ECE/TRANS/WP.29/GRRF/2009/23
6 July 2009

Regulation No. 90
(Replacement brake linings)

Proposal for amendments to Regulation No. 90

Submitted by the expert from Germany */

Annex 2

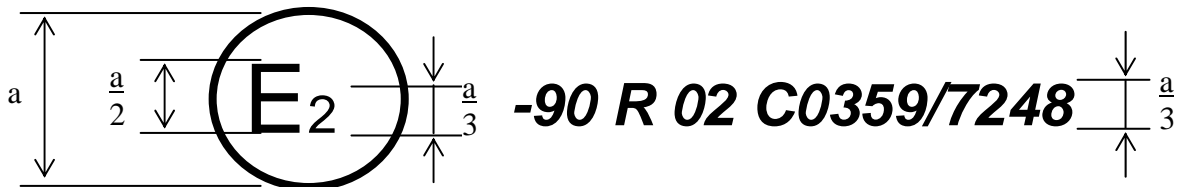
Existing approval mark and its explanatory text, amend to read:

The above approval mark shows that the item concerned has been approved in **France (E2)** pursuant to Regulation No. 90 under approval number **C0359/7248**. **The first two digits of the approval number indicate that the approval was granted in accordance with the requirements of Regulation No. 90 in its original form.**"
